# Staff Report

## Site Plan Review

SP-31-18

Proposal:	Site Plan Review for a Change of Use from a Restaurant to a Community Service Use, named CHANCE (Community Helping Addicts Negotiate Change Effectively)
Review Body:	Staff (Type I-L review)
Report Prepared By:	Melissa Anderson, Senior Planner
Property Owner:	Stark Group, LLC; 3621 NW Yeon, Portland, OR 97210
Applicant:	Jeff Blackford; 238 3 <sup>rd</sup> Avenue SE, Albany, OR 97321
Address/Location	231 Lyon Street SE
Map/Tax Lot:	Linn County Tax Assessor's Map No. 11S-03W-06CD; Tax Lot 1900
Zoning District:	Historic Downtown (HD)
Comprehensive Plan Map Designation	Village Center
Total Land Area	6,709 square feet
Existing Land Use:	Vacant
Neighborhood:	Central Albany
Surrounding Zoning:	North: Historic Downtown (HD)

231 Lyon Street  
Albany, OR  
97321

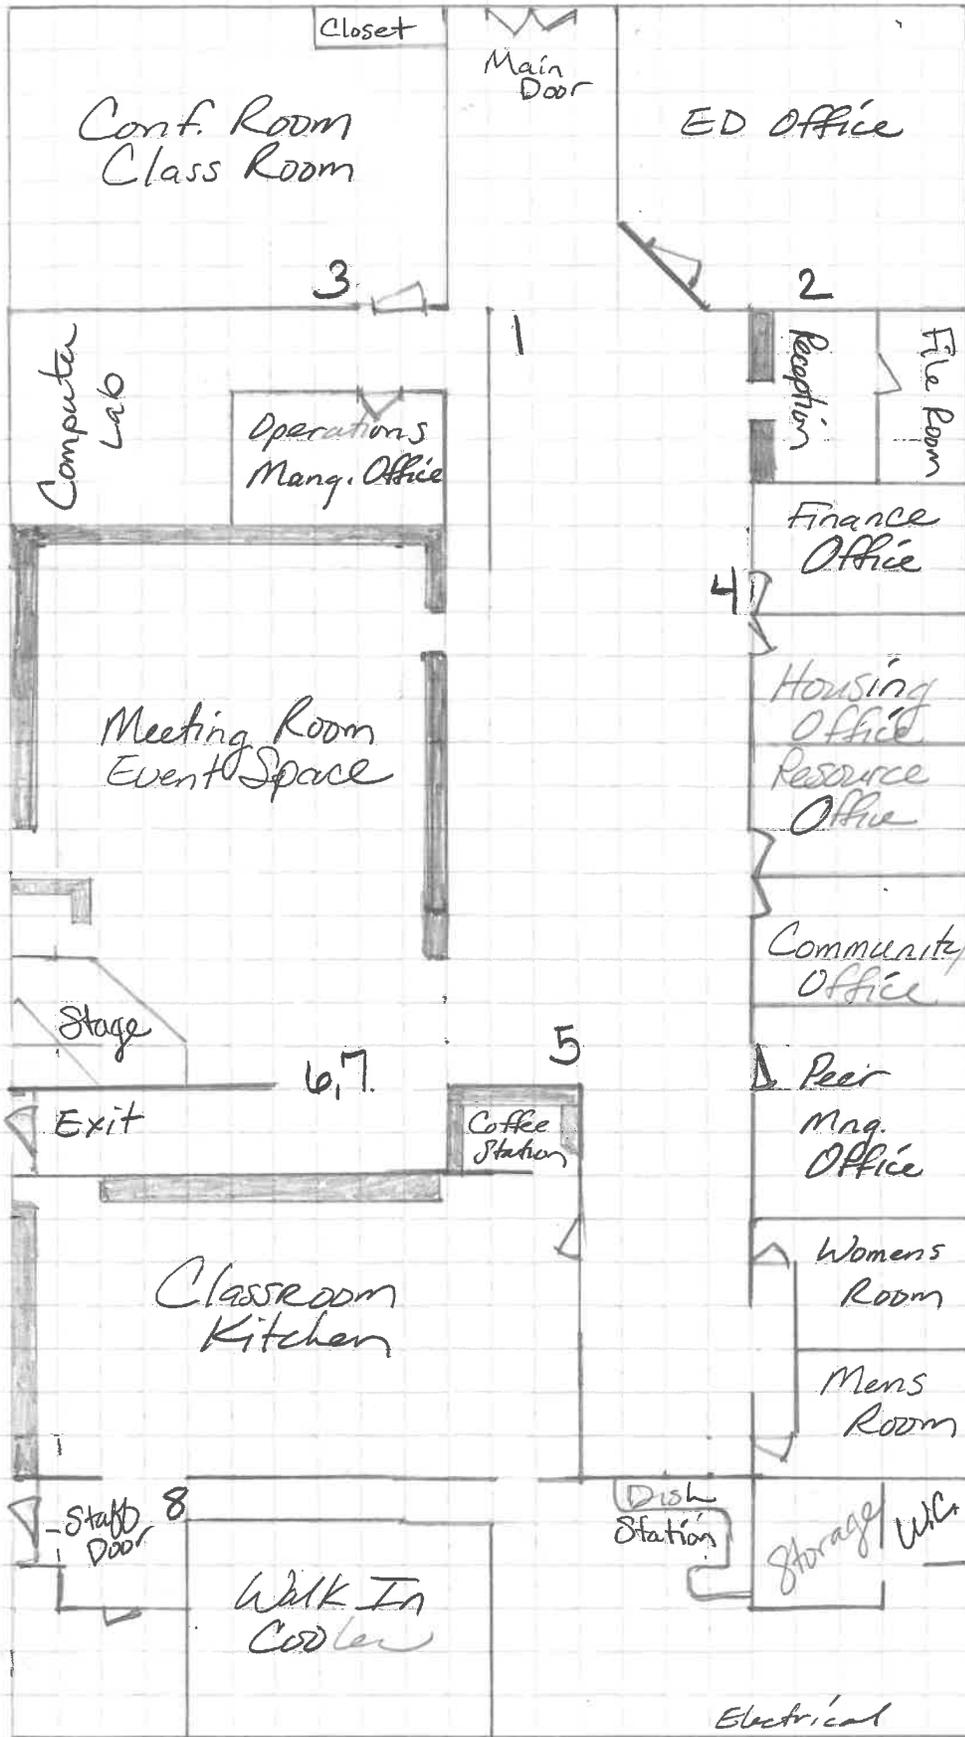
The applicant states that they will either: 1) keep refuse containers inside the building and roll them out to the curb for weekly pick-up, 2) work with DHS to share space in their refuse area by their parking lot, or 3) create a screened area located by the back door of the building. This third option proposed by the applicant is not possible because the existing building is built out to all property lines and any new refuse area would have to be located off-site, within the public way. A condition of approval will be included to clarify that any new refuse container area must be located outside of the public way and screened from view.

- Condition 1 If a new refuse container area is located outside in the future, it must be located outside of the public way, on private property, and screened from view in accordance with ADC 5.370.
